STATE OF NEBRASKA
DEPARTMENT OF ROADS
ADDENDUM NO. 3
PROJECT NO. IM-80-9(891)
CONTROL NO. 12729
CALL NO. 100
I-80, PLATTE RIVER REST AREA
LETTING DATE: JUNE 16, 2011

PROJECT: NEBRASKA DEPARTMENT OF ROADS
PLATTE RIVER REST AREA
JOB NO: 05450.001

SHEET TITLE: CANOPY FRAMING

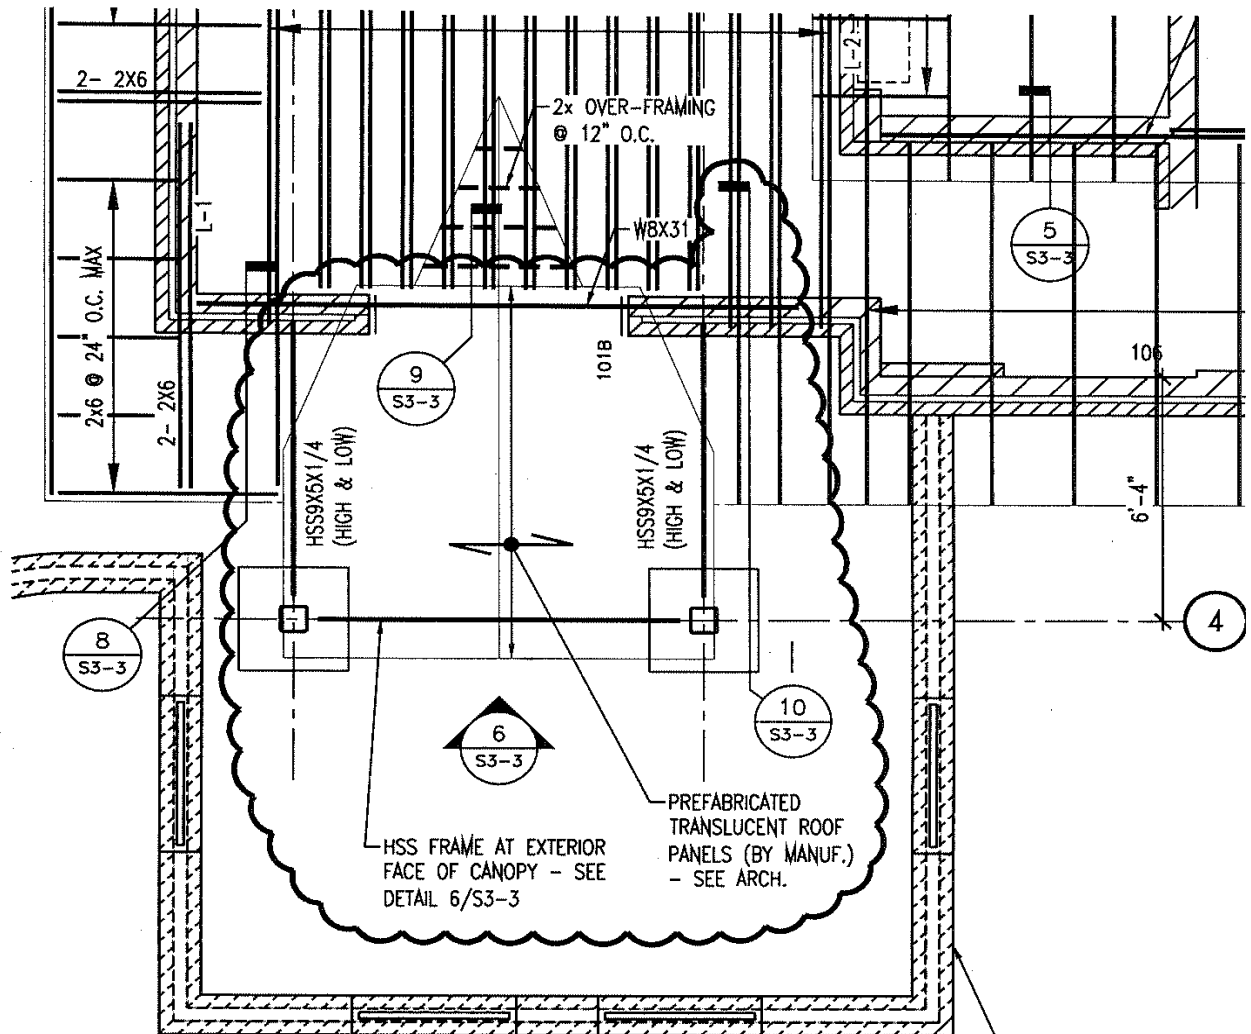
On plan sheet 31, the ROOF FRAMING PLAN is amended as per "SUPPLEMENTAL DRAWING, REF: 1/S1-2" depicted on the attached sheet.

NOTE:
CHANGES ALSO APPLY
TO NORTH CANOPY.

SHEET TITLE: HSS BEAMS AT HSS COLUMN OF CANOPY

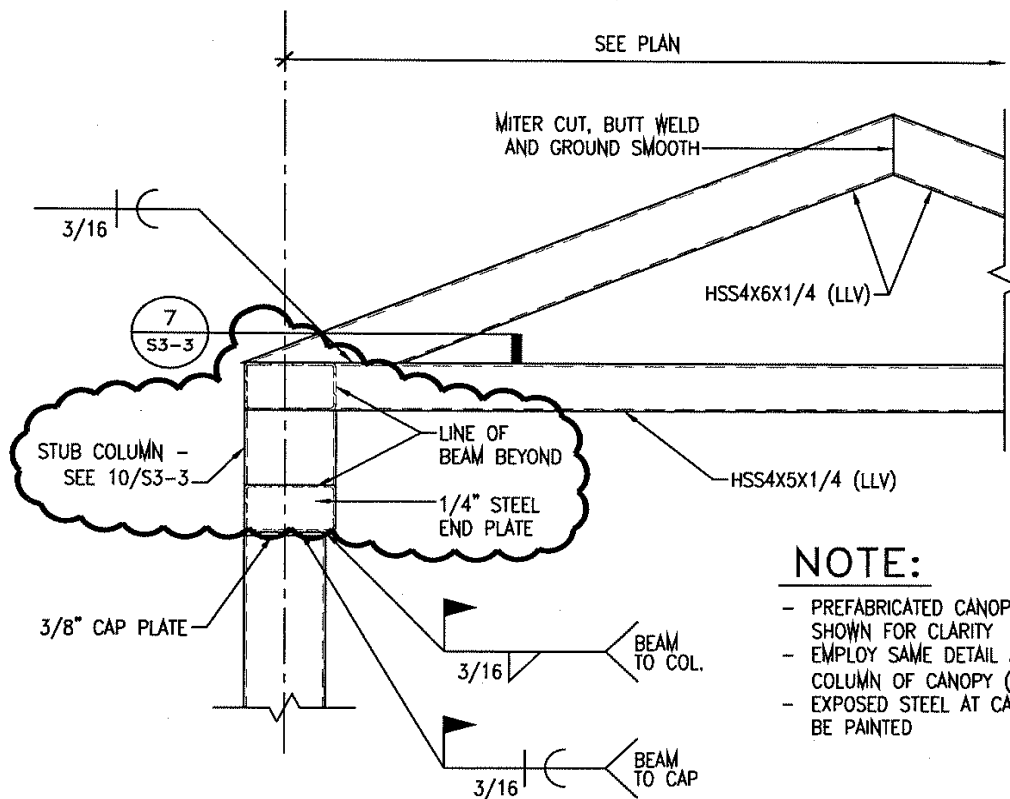
1. Drawing (6) "HSS Beams At HSS Column Of Canopy" is amended as per the "SUPPLEMENTAL DRAWING, REF: 6/S3-3" as depicted on the attached sheet.
2. Drawing (10) "HSS Canopy Beam At Steel Lintel" is void and superseded by the "SUPPLEMENTAL DRAWING, REF: 10/S3-3" as depicted on the attached sheet.

- PREFABRICATED CANOPY ROOF NOT SHOWN FOR CLARITY
- EMPLOY SAME DETAIL AT OPPOSITE COLUMN OF CANOPY (NOT SHOWN)
- EXPOSED STEEL AT CANOPY SHALL BE PAINTED
